April 14, 2011

Ms. Kathleen Woods  
Director of Standards  
Outdoor Power Equipment Institute  
341 South Patrick Street  
Alexandria, VA 22314

On January 11, 2011, the U.S. Consumer Product Safety Commission (CPSC) staff received the second canvass draft of ANSI/OPEI B71.9-20XX, *American National Standard for Multipurpose Off-Highway Utility Vehicles*.<sup>1</sup> CPSC staff reviewed the draft and believes that the proposed standard does not adequately address vehicle stability, vehicle handling, and occupant protection performance.

**Figure 1. Modifications to improve steering characteristics.**

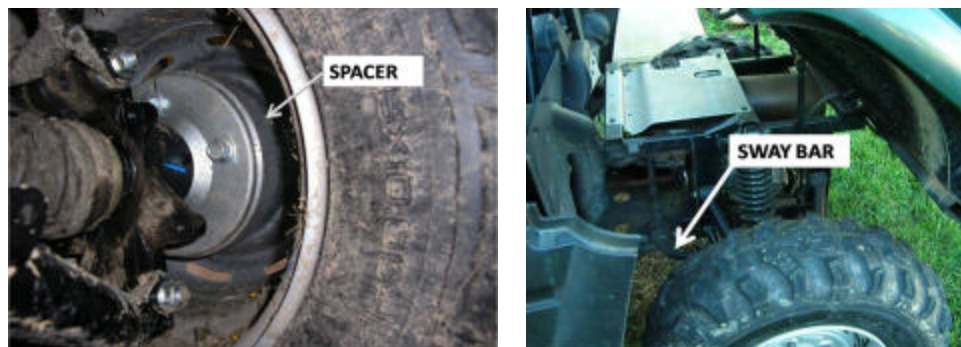
CPSC staff continues to believe that steady state oversteer is an undesirable and unstable steering control mode for vehicles. Therefore, staff believes that a test to measure steering gradient and an acceptance criterion for handling characteristics is necessary. CPSC staff’s experience with vehicle dynamic testing has shown that altering the steering characteristics of a vehicle is not difficult. Staff successfully altered the steering characteristics of a vehicle that originally exhibited steady state oversteer by adding spacers to the rear wheels and removing the rear sway bar (see Figure 1).

**Figure 2. Steering diagram of unmodified vehicle and modified vehicle in clockwise (CW) and counterclockwise (CCW) directions.**

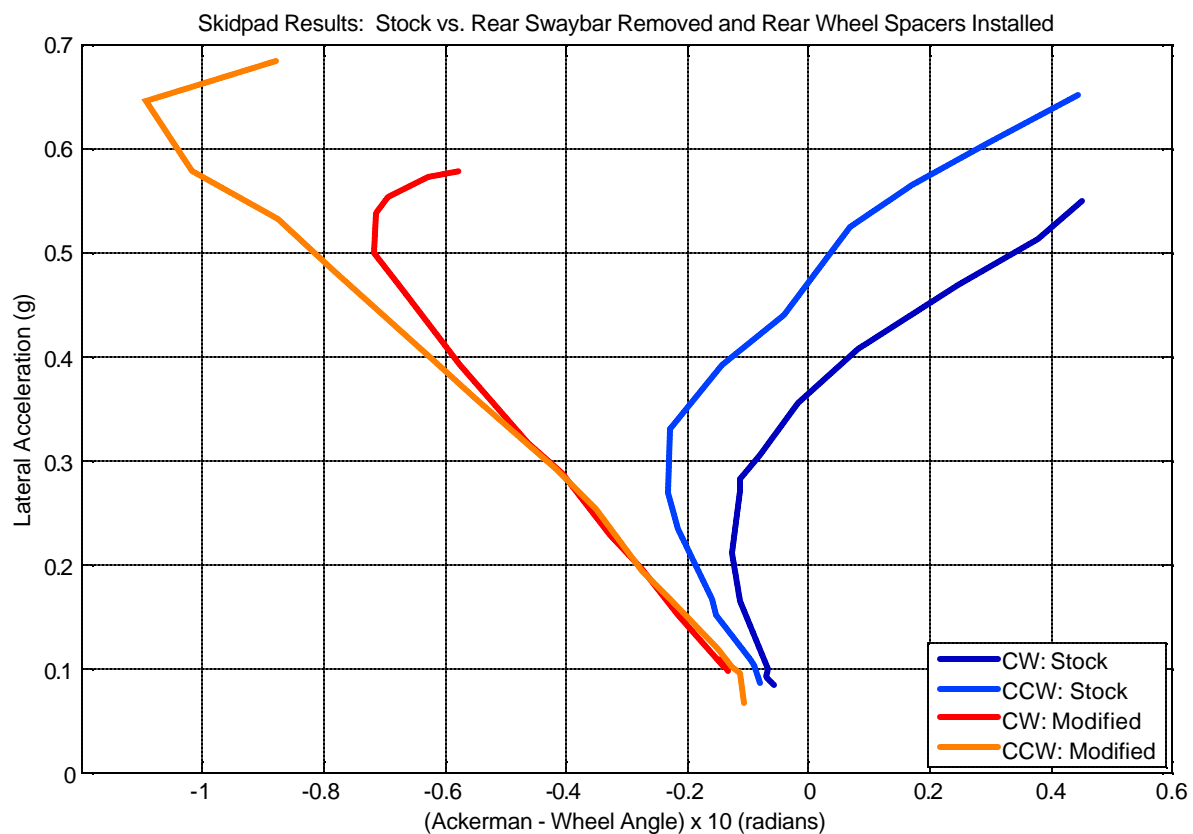
The effectiveness of the modifications in improving the vehicle from oversteer (blue lines) to understeer (red and orange lines) is illustrated in the vehicle diagram shown in Figure 2.
